November 21, 2017

Re: Request for Consideration of Changes
Petition No. 1234

DEVELOPMENT & MANAGEMENT PLAN

Proposed Conditions Map

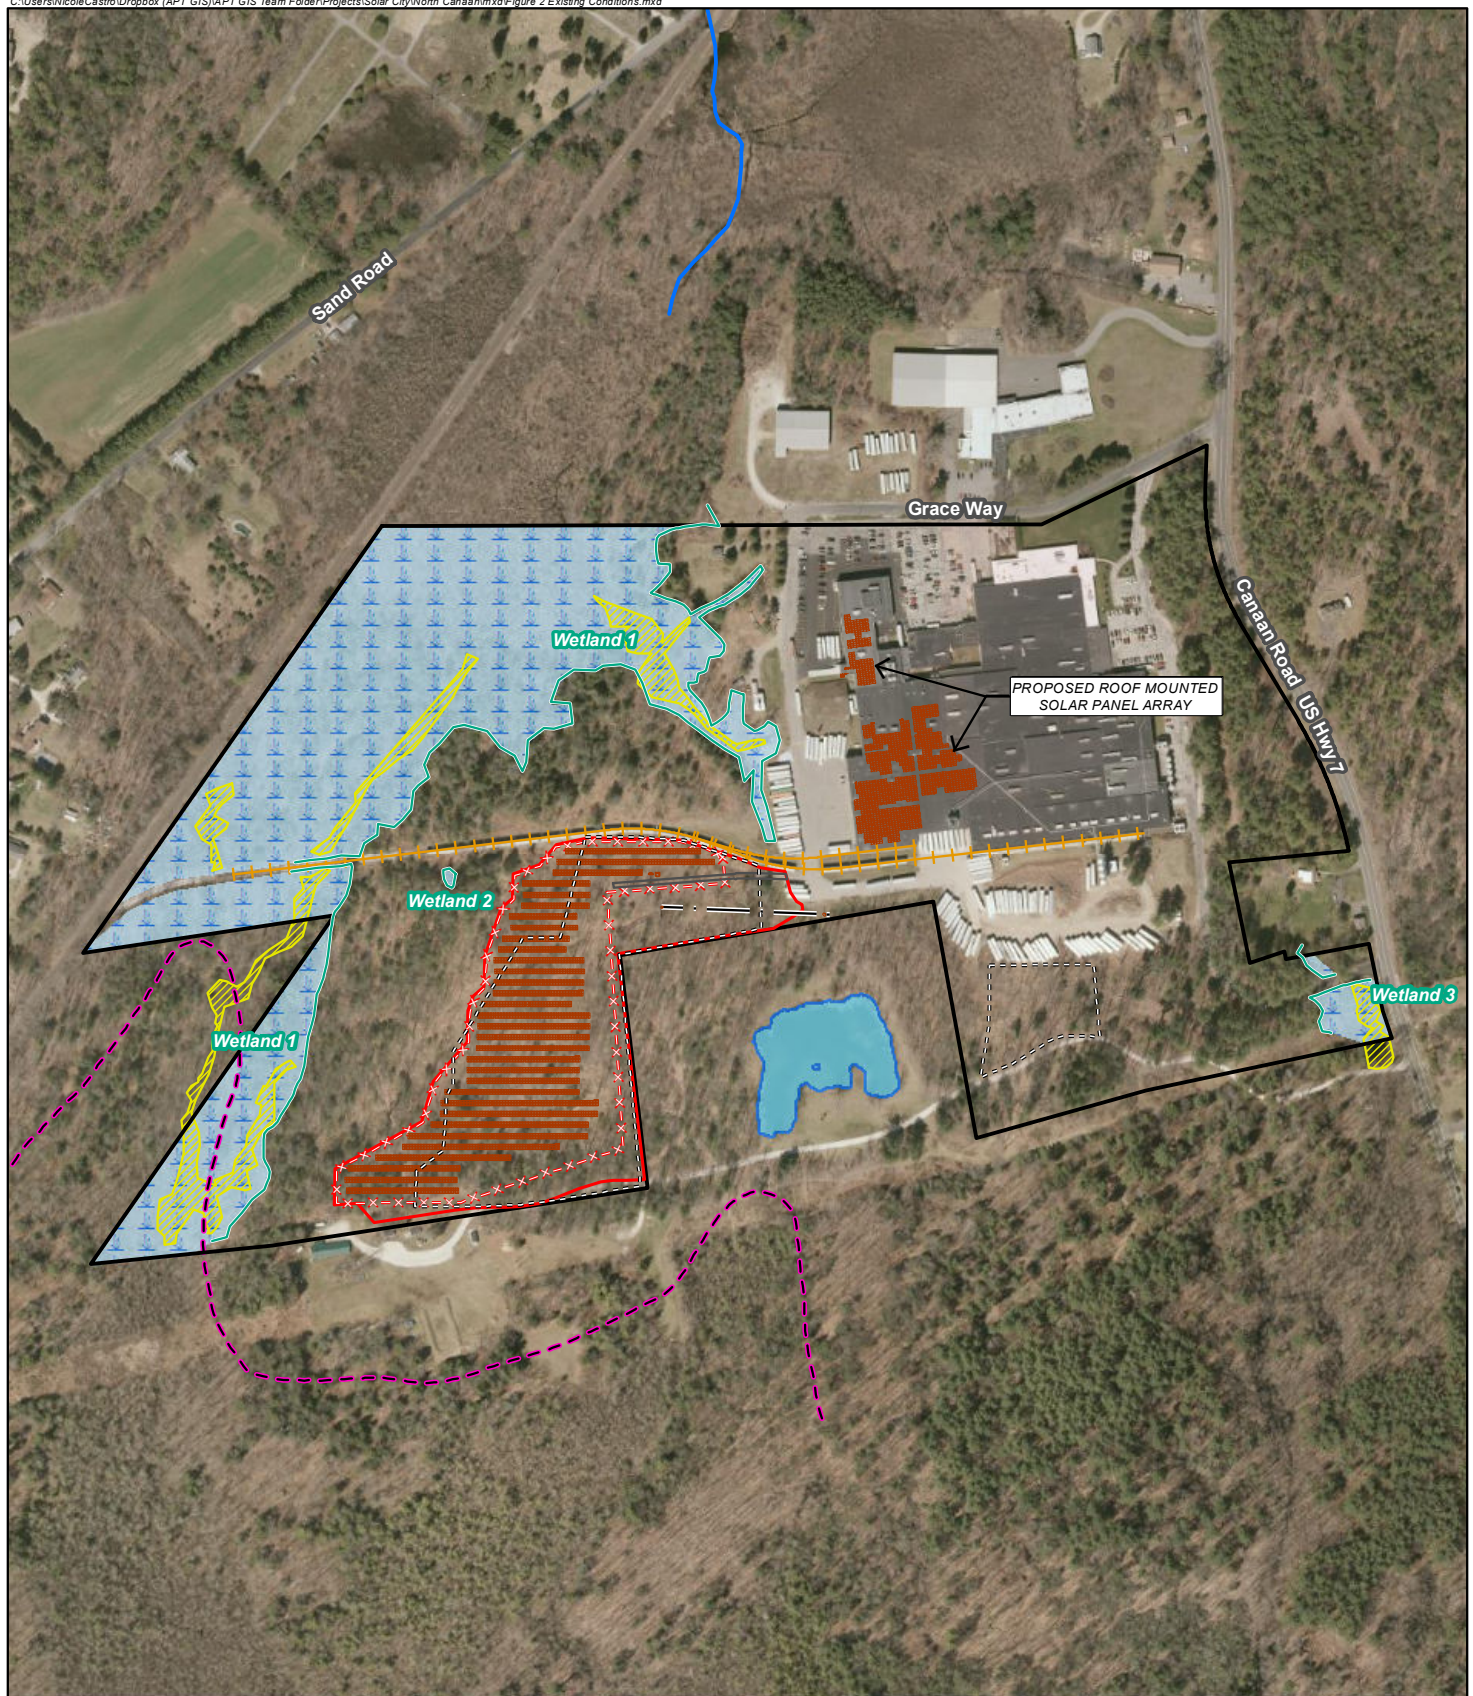
- Removal of the eastern ground-mounted solar panel array (a total of 756 panels) and associated improvements;
- Reduction of the western ground mounted solar panel array from 6,404 to 4,680 panels;
- Revision to layout and clearing limits of the western array to minimize shading, resulting in an increase of the total project clearing from ± 9.0 acres to ± 9.9 acres; and,
- Revision to Sedimentation and Erosion Control Plans due to the time of year construction.

These proposed modifications to the project site plans are depicted on the attached plans. A Proposed Conditions Map is also enclosed depicting the previously reviewed solar facility layout and the modified layout. The modifications will not directly impact wetland or vernal pool habitats and still provide a significant buffer to these resources.

Vernal Pool Analysis Map

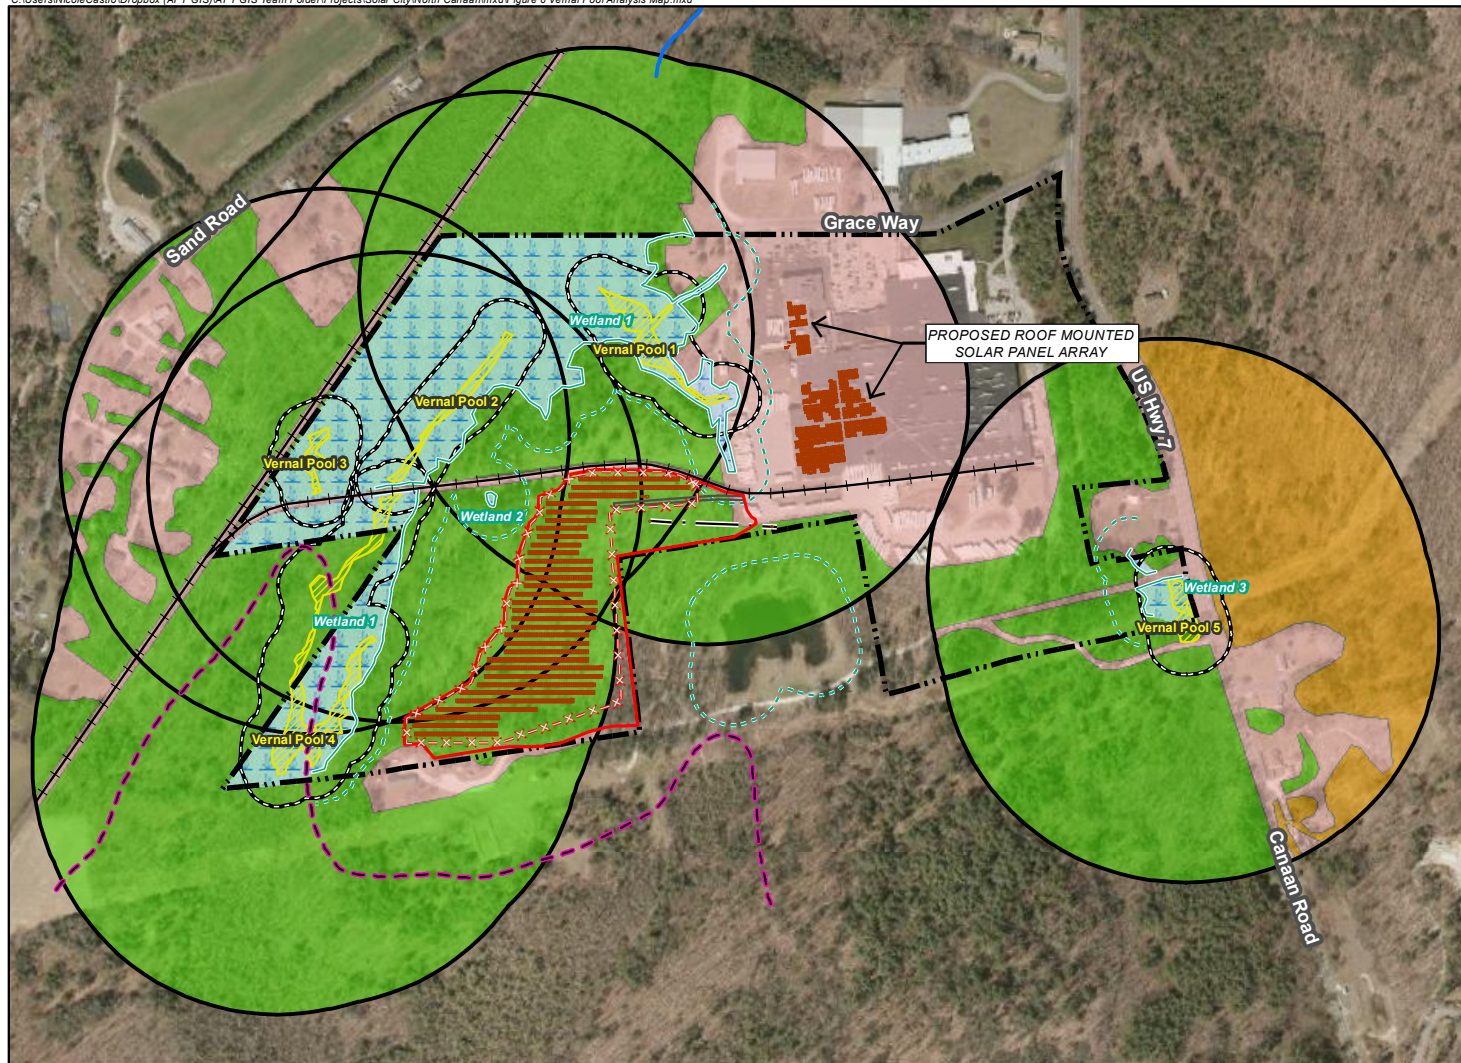
Vernal Pool 1 is a Tier 1 pool using the pre-development assessment methodology, but already contains 36% development within the CTH. Because the BDP guidelines recommend no more than 25% development within the CTH, Pool 1 is currently not in compliance with the BDP. A strict interpretation of the guidelines would indicate that no additional development should occur within this Vernal Pool's CTH. The Project had been through numerous iterations and was re-designed to minimize development within this area. The proposed modified layout results in a small increase of 8% within the Pool's CTH; the previously reviewed layout resulted in a CTH increase of 6%. See attached Vernal Pool Analysis Map.

At present, the VPE zone of Vernal Pool 1 is constricted to the east, with disturbed/degraded habitat present along the pool's perimeter. Recognizing the Project's encroachment into the CTH, a Vernal Pool Mitigation Plan has been proposed, and approved through the CT Siting Council, to offset habitat loss through habitat restoration. The mitigation plan will re-establish portions of this important habitat zone, resulting in a single contiguous band of available VPE habitat post-restoration.
